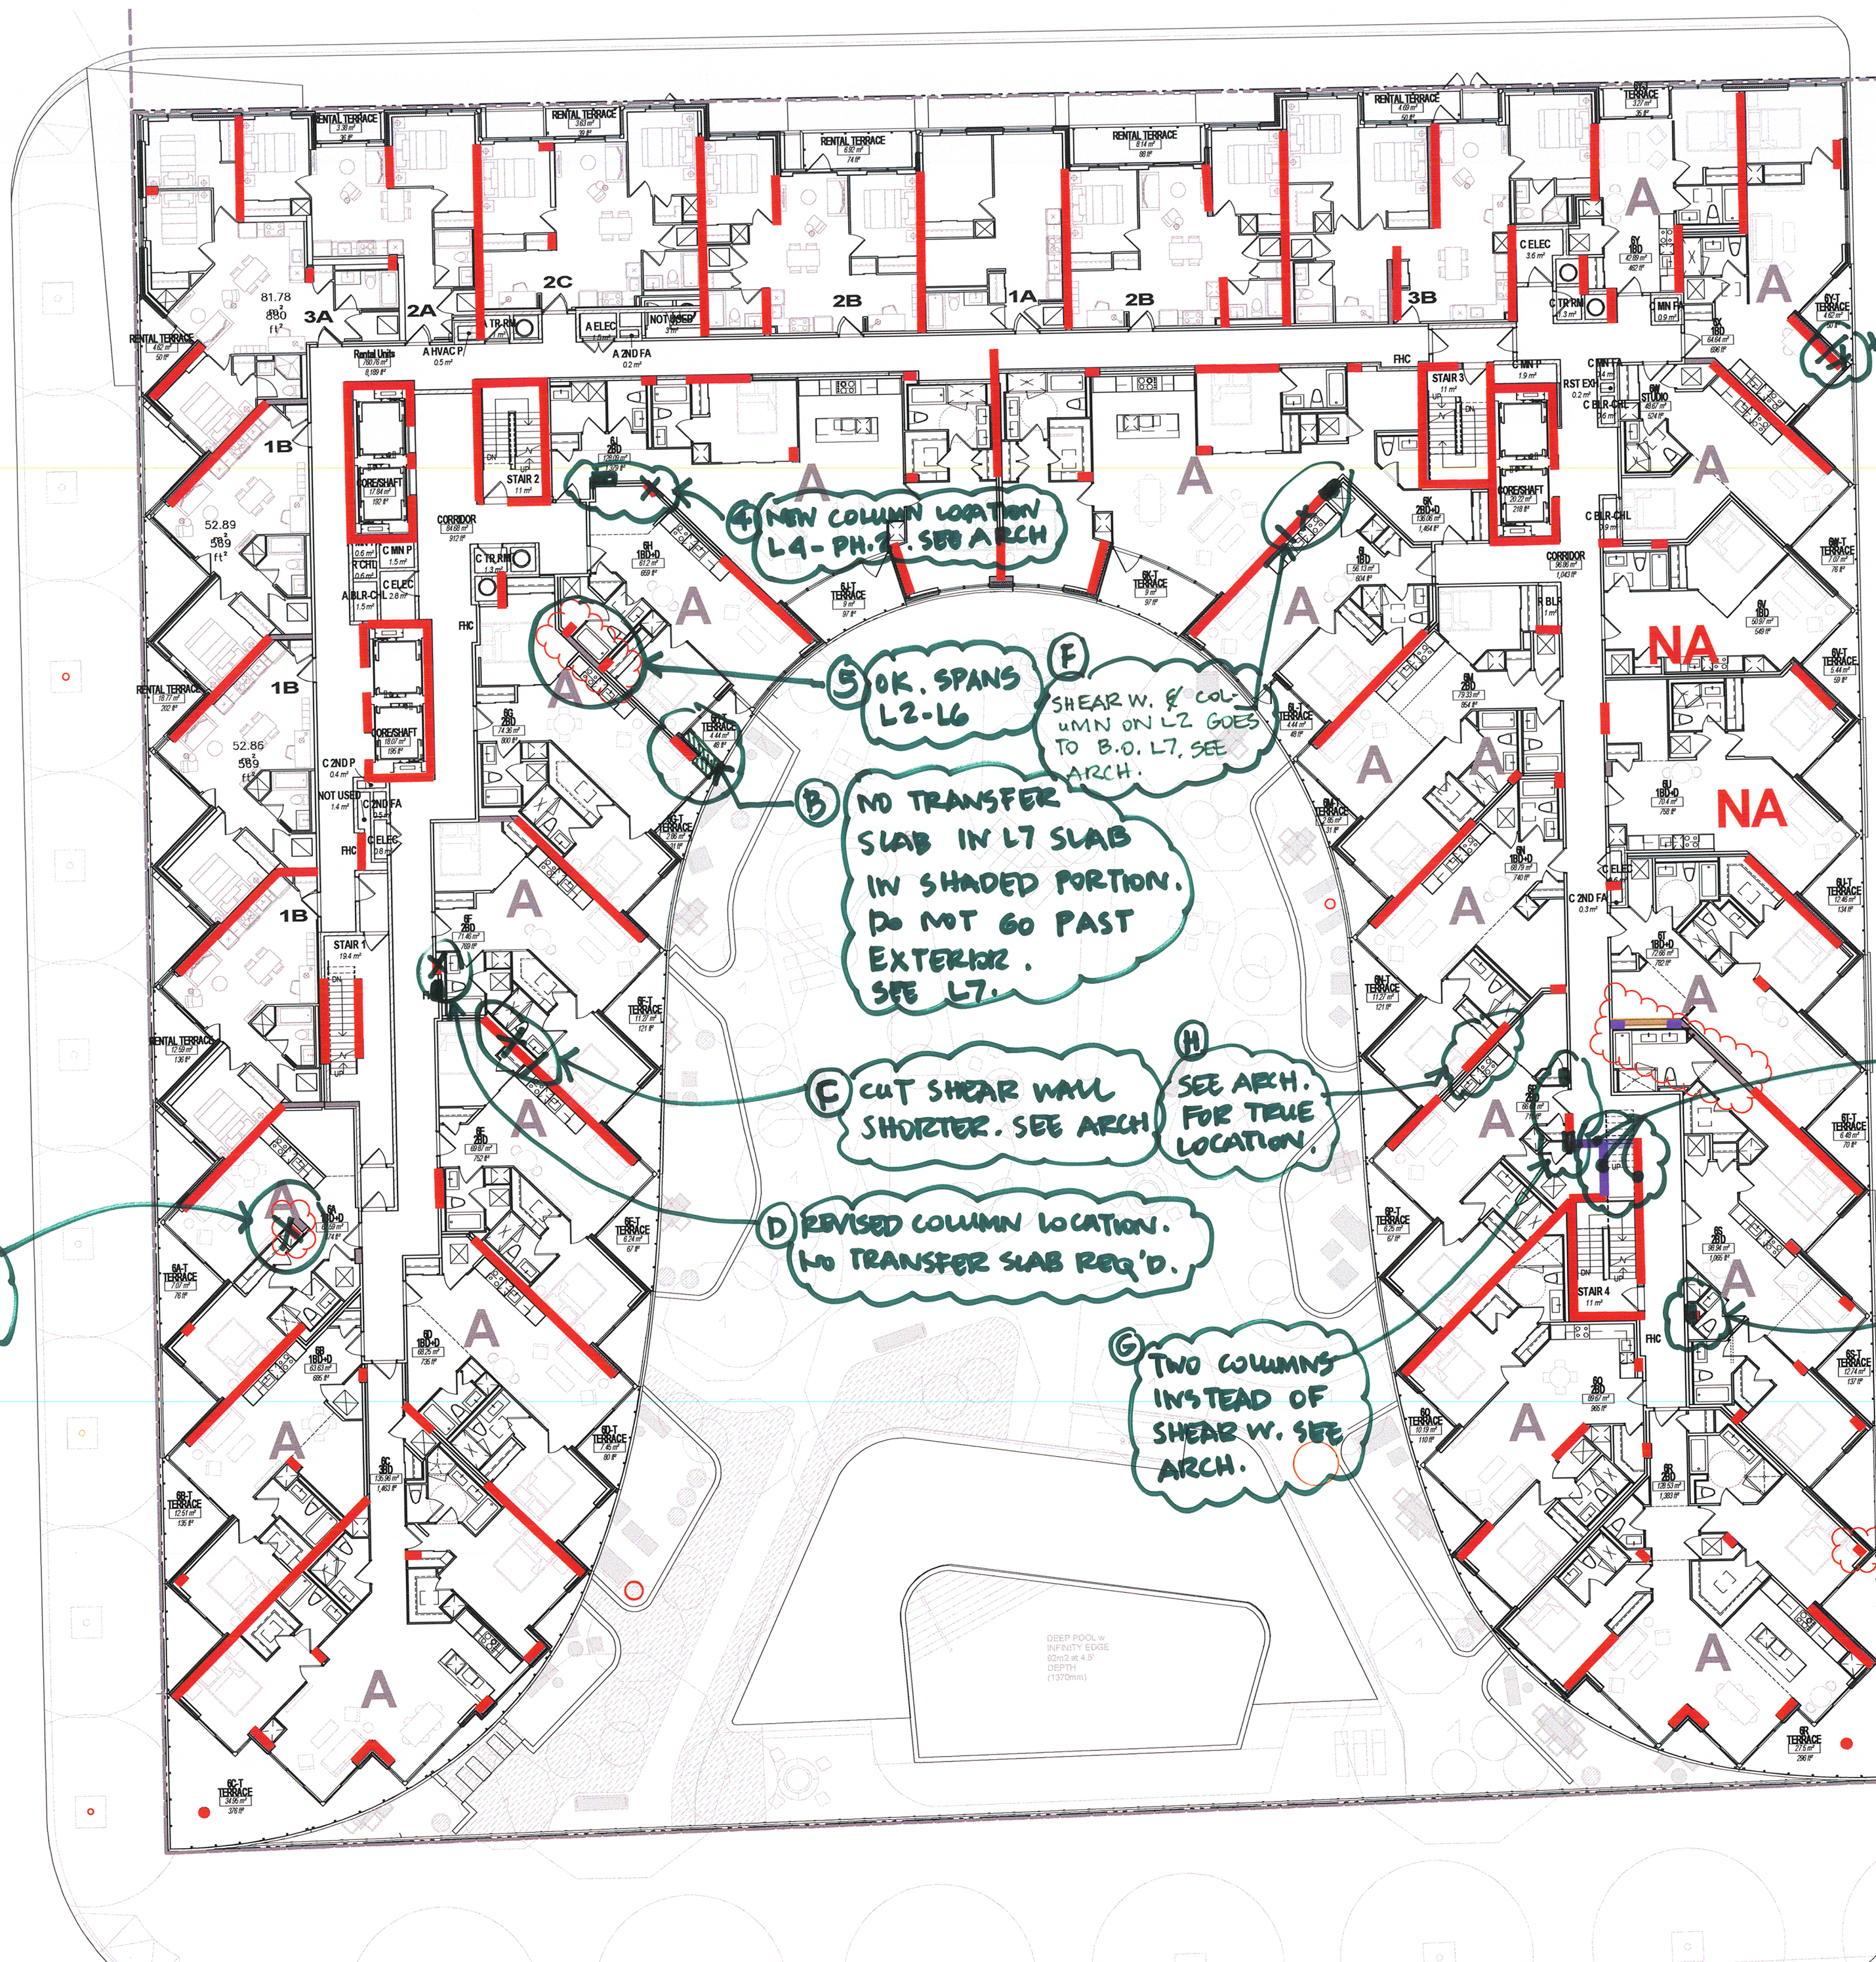
7 CUT SHEAR WALL SHORTER. SEE ARCH.

8 SEE ARCH FOR TRUE LOCATION

9 TWO COLUMNS INSTEAD OF SHEAR W. SEE ARCH.

10 COLUMN ROTATED. SEE ARCH.

11 SEE COMMENT ON L2

③ CUT BACK SHEAR WALL. SEE ARCH.

④ REPLACE COLUMN W/ SHEAR WALL. SEE ARCH.

⑤ WHY NOT KEEP SHEAR W. ON L7-L10? IT EXISTS ON L2-L6. SEE ARCH.

⑥ PURPLE SHEAR WALLS NOT SUPPORTED BELOW. CLARIFY.

⑦ COLUMN IN BEDRM INTERFERES W/ LAYOUT. REPLACE IT W/ SHEAR W. L7 & UP. SEE ARCH.

⑧ COLUMN CAP REQ'D IN L7 SLAB DUE TO SLIGHT COLUMN PLACEMENT ON L6. SEE ARCH.

① KEEP COLUMN AS IN ARCH. TRANSFER SLAB IN L7 SLAB

② NEW COLUMN LOCATION ON L4-PH2 SEE ARCH.
⑤ KEEP SHEAR WALL AS IN ARCH. L7 AND UP.

⑥ NO TRANSFER SLAB IN L7 SLAB IN SHADED PORTION. DO NOT GO PAST EXTERIOR. SEE L6

⑦ CUT SHEAR WALL SHORTER. SEE ARCH.

⑧ REMOVED COLUMN LOCATION. NO TRANS. FOR SLAB REQ'D.

⑨ CUT SHEAR WALL SHORT. ADD COLUMN. SEE ARCH.

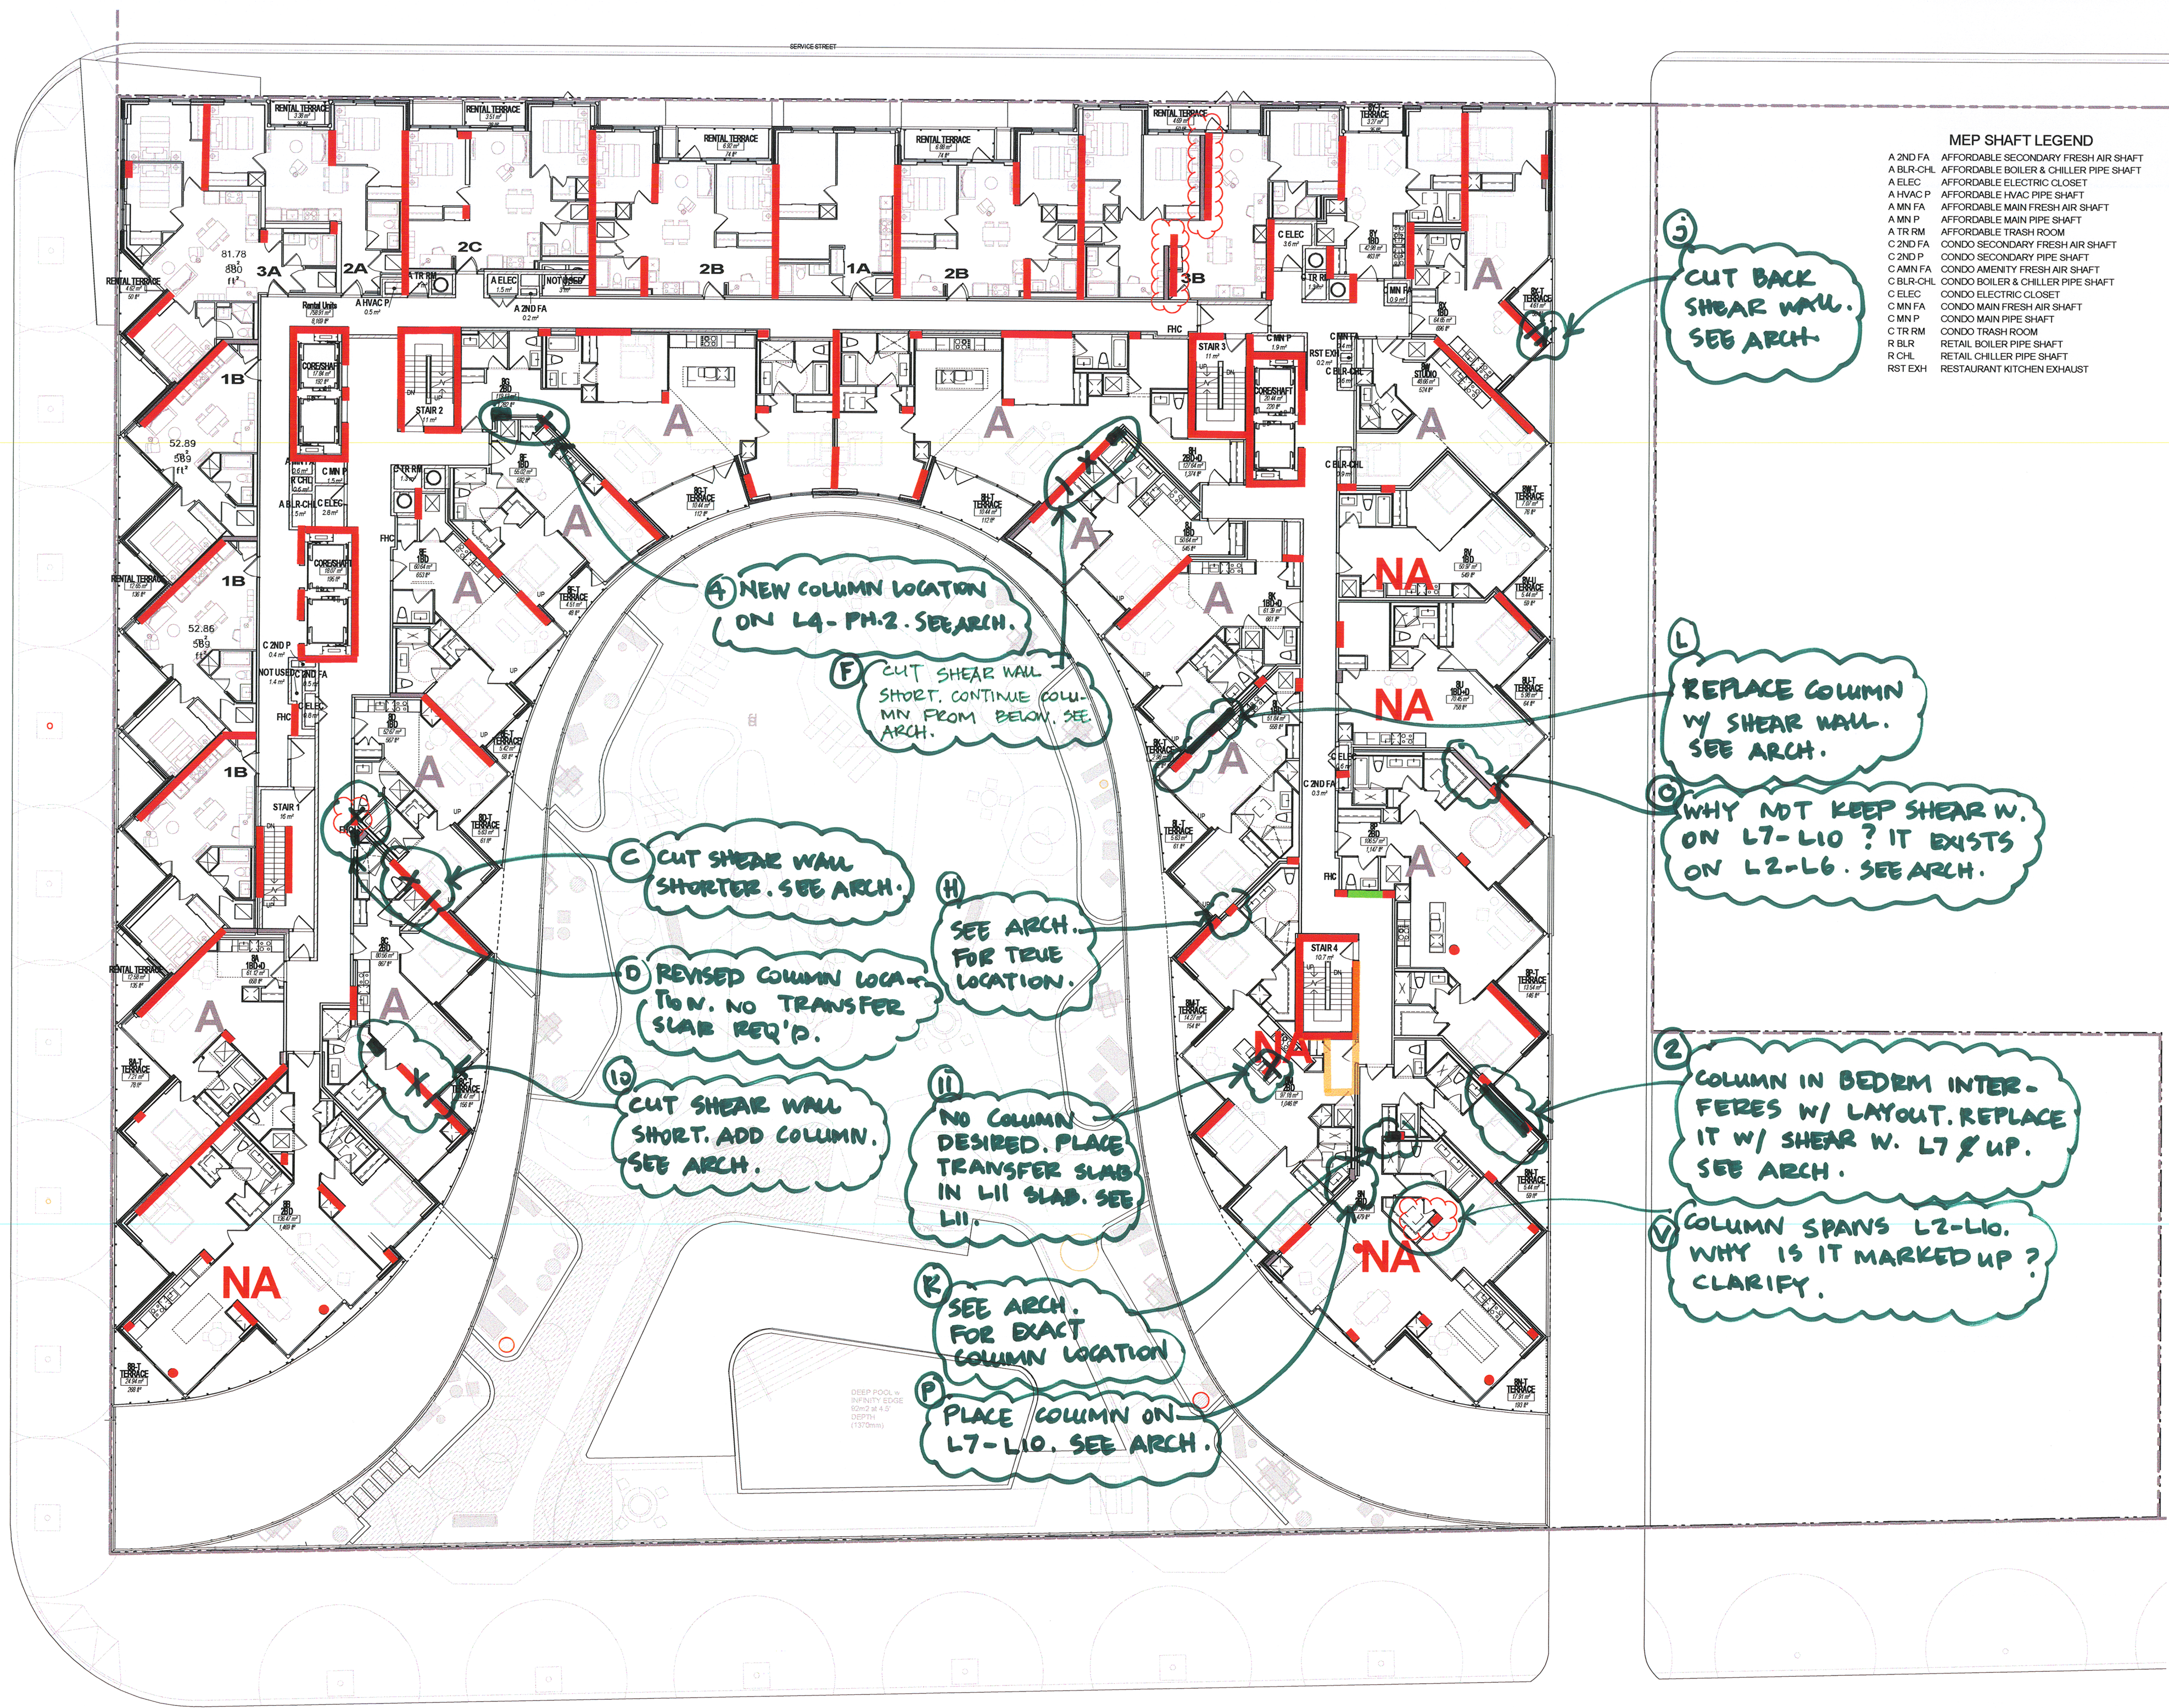
⑩ NO COLUMN DESIRED. PLACE TRANSFER SLAB IN L11 SLAB. SEE L11.

⑪ COLUMN CAP REQ'D IN L7 SLAB. SEE ARCH.

⑫ COLUMN SPANS L2-L10. WHY IS IT MARKED UP?

⑬ CUT SHEAR WALL SHORT. CON. TIME COLUMN FROM BELOW. SEE ARCH.

⑭ SEE ARCH. FOR TRUE LOCATION.

3 CUT BACK SHEAR WALL. SEE ARCH.

L REPLACE COLUMN W/ SHEAR WALL. SEE ARCH.

C WHY NOT KEEP SHEAR W. ON L7-L10? IT EXISTS ON L2-L6. SEE ARCH.

2 COLUMN IN BEDRM INTERFERES W/ LAYOUT. REPLACE IT W/ SHEAR W. L7 & UP. SEE ARCH.

V COLUMN SPANS L2-L10. WHY IS IT MARKED UP? CLARIFY.

4 NEW COLUMN LOCATION ON L4-PH.2. SEE ARCH.

F CUT SHEAR WALL SHORT. CONTINUE COLUMN FROM BELOW. SEE ARCH.

C CUT SHEAR WALL SHORTER. SEE ARCH.

D REVISED COLUMN LOCATION. NO TRANSFER SLAB REQ'D.

10 CUT SHEAR WALL SHORT. ADD COLUMN. SEE ARCH.

H SEE ARCH. FOR TRUE LOCATION.

11 NO COLUMN DESIRED. PLACE TRANSFER SLAB IN L11 SLAB. SEE L11.

K SEE ARCH. FOR EXACT COLUMN LOCATION

P PLACE COLUMN ON L7-L10. SEE ARCH.
